Ref: 0417r02v02

**RE: 227 BUNGARRIBEE ROAD, BLACKTOWN (DA-21-00559)
KRISHATHI PTY LIMITED -V- BLACKTOWN CITY COUNCIL (LEC CASE NO. 2021 / 146822)
LETTER OF RESPONSE TO TRAFFIC CONTENTIONS**

We refer to recent correspondence concerning the abovementioned Court proceedings and the Statement of Facts and Contentions (SOFC) issued by Blacktown City Council (Council) dated 14/07/2021, relating to the deemed refusal of Development Application, DA-21-00559.

Attachment 2

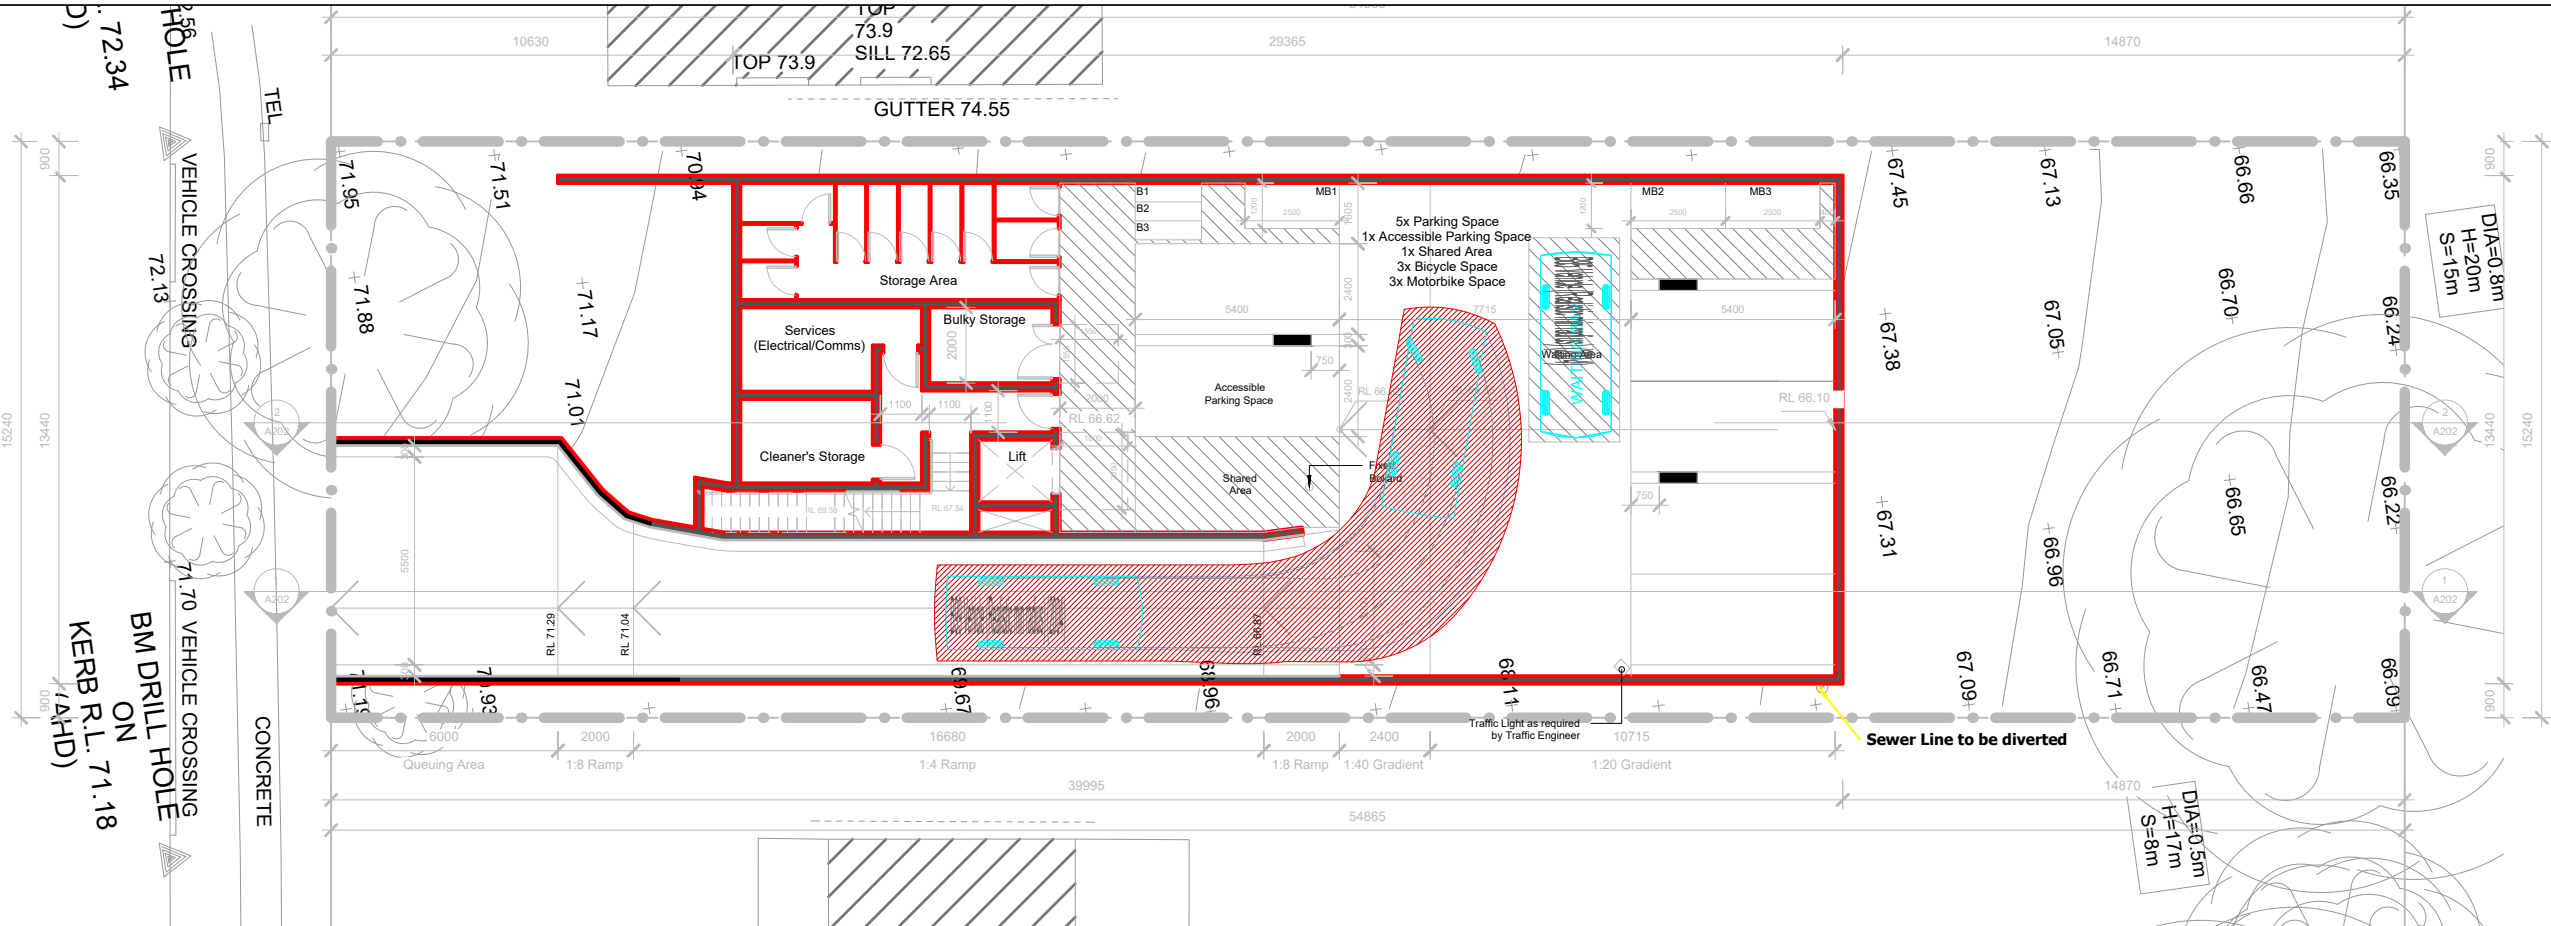
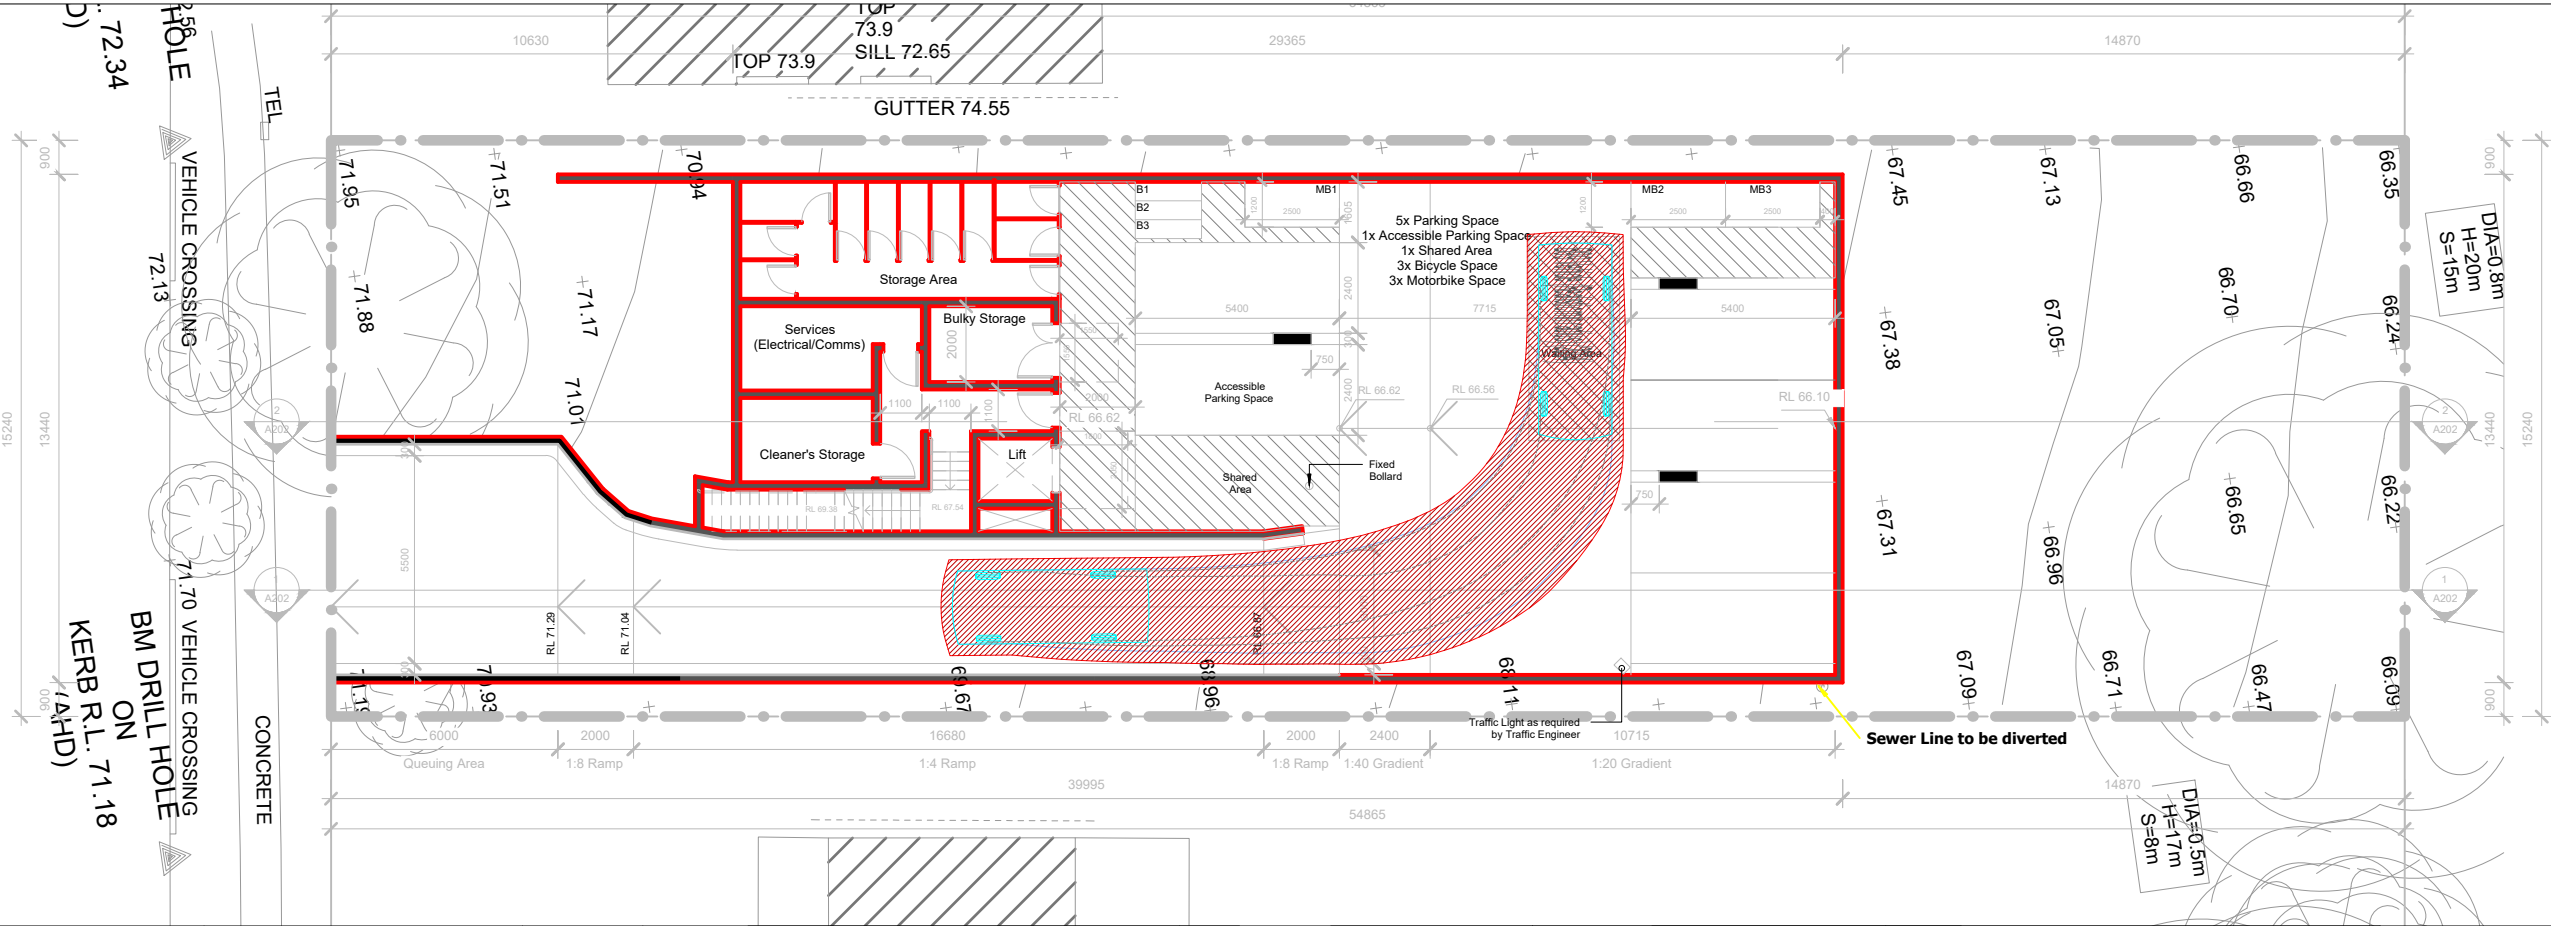
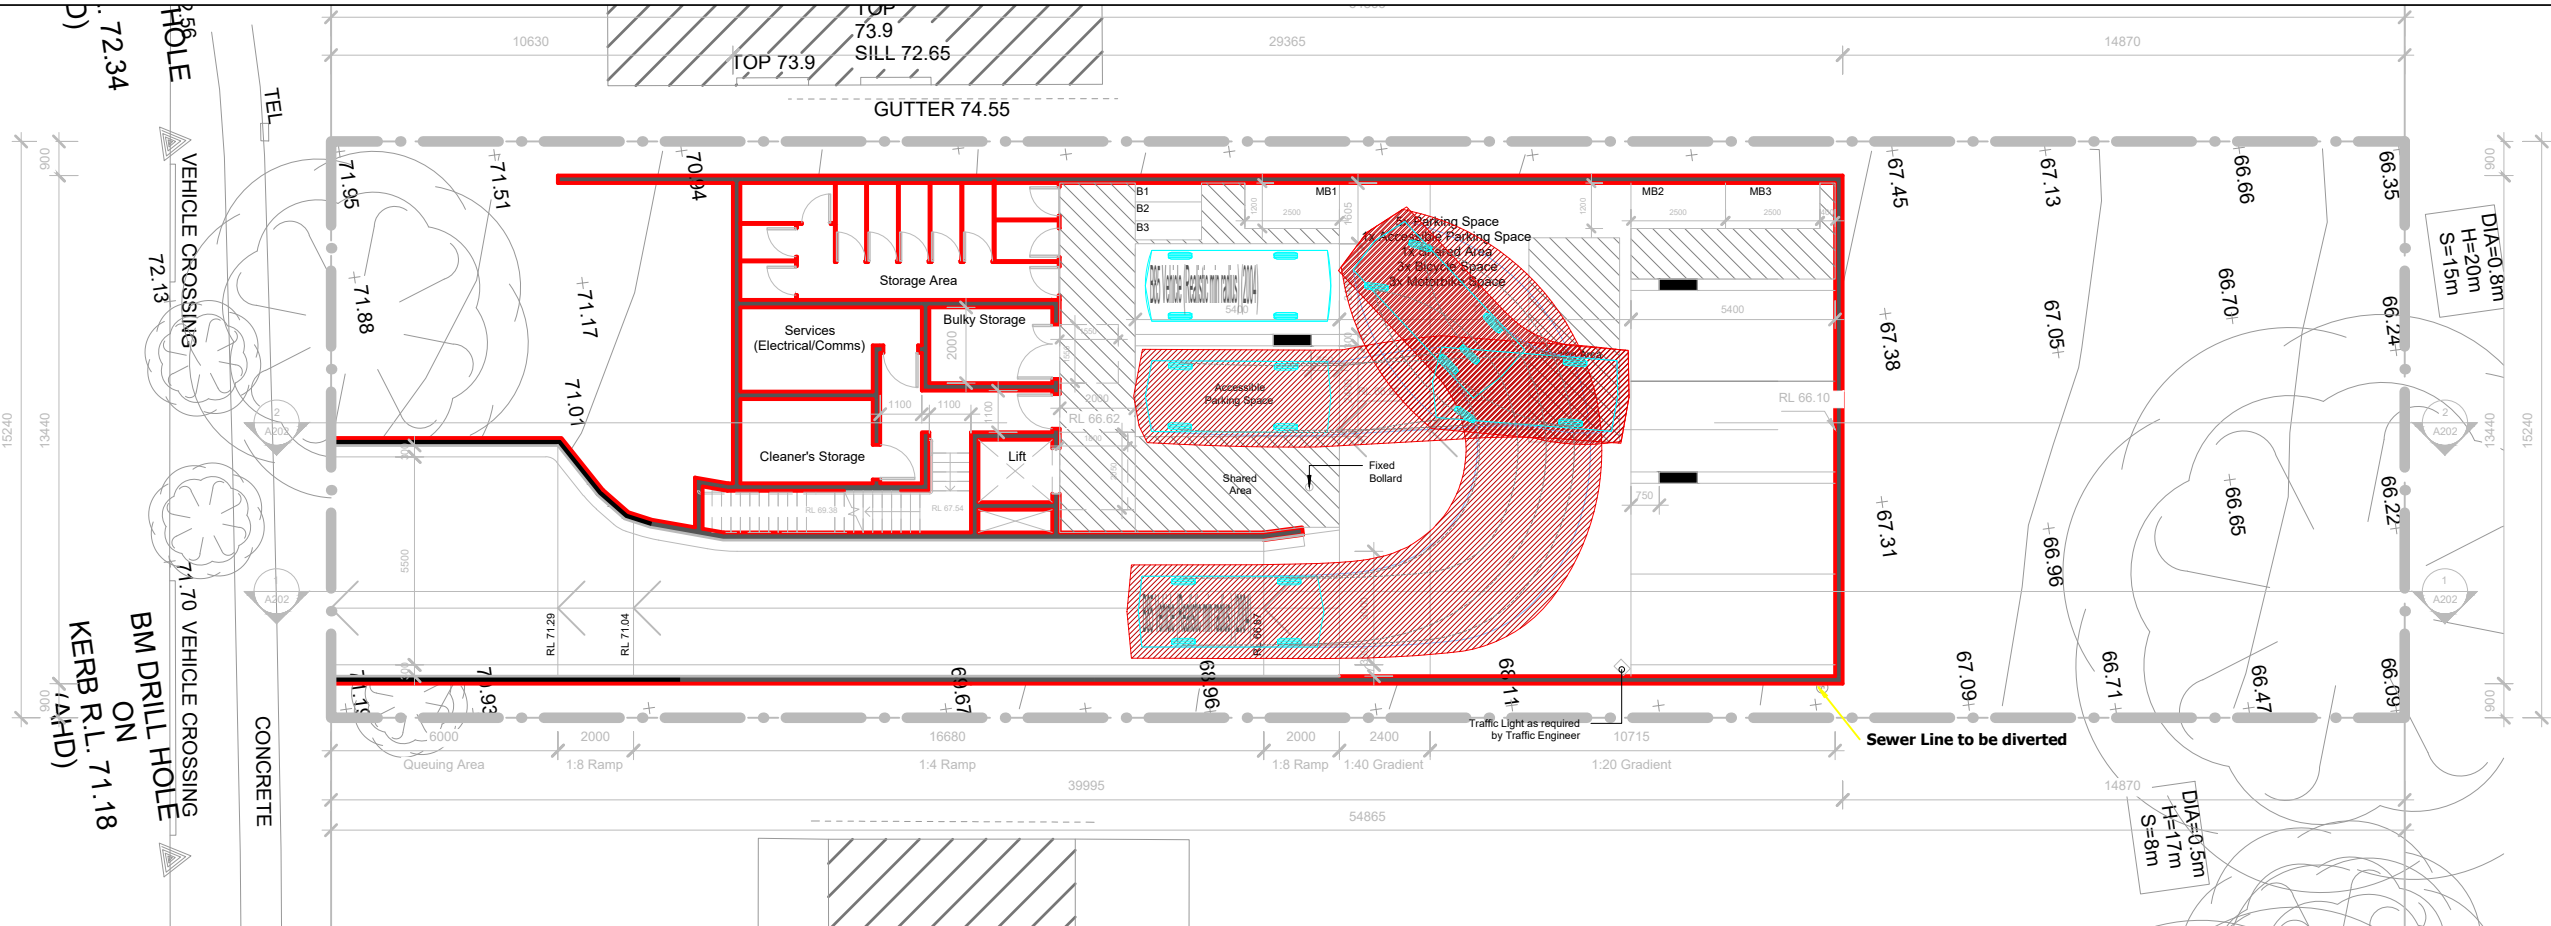
b) Insufficient turning circles have been provided in accordance with Section 2.5.2 of AS2890.1 for passing at the site driveway and within the basement. Turning paths are to be provided for the B99 design vehicle turning left into the site driveway from the public road and passing a B85 design vehicle exiting the site in addition to swept paths for the B99 design vehicle within areas designed for use by one vehicle at a time.

d) Turning circles in the basement are not practical or workable for cars. The results show the required 0.3m vehicle clearance overlapping with high obstructions (walls, columns, motorcycle spaces, kerbs and car parking spaces) which is contrary to the requirements of AS2890.1. It appears 'turn on spot' has been used for swept paths (basement and along the driveway) which is a design flaw not representing realistic vehicle manoeuvres. The dwg files for the swept paths are to be provided.

Updated swept path analysis has been undertaken of the vehicle access with the results provided as **Attachment 2**. The results demonstrate satisfactory turn movements for a:

- B99 Design Vehicle turning left-in and left-out of the access driveway from the public road and passing a B85 Design Vehicle.
- B99 Design Vehicle entering the basement car park and passing a B85 Design Vehicle situated within the waiting bay.
- B99 Design Vehicle exiting the basement car park.
- B85 Design Vehicle entering / exiting all car spaces.

The results demonstrate satisfactory operation of the car park and compliance with Appendix B of AS 2890.1.

As per our respond to Contention 6(b), updated swept path analysis has been undertaken of the basement, including for entry / exit to all car spaces with the results provided in **Attachment 2**.

The 'turn from stop' function has only been used where a vehicle has changed from a forward-movement to a reverse-movement or from a reverse-movement to a forward-movement as is standard practice in the traffic engineering profession. The updated swept path results also show that 0.3m clearances are now clear of all vehicle obstructions including walls, columns, motorcycle spaces, kerbs and car parking spaces.
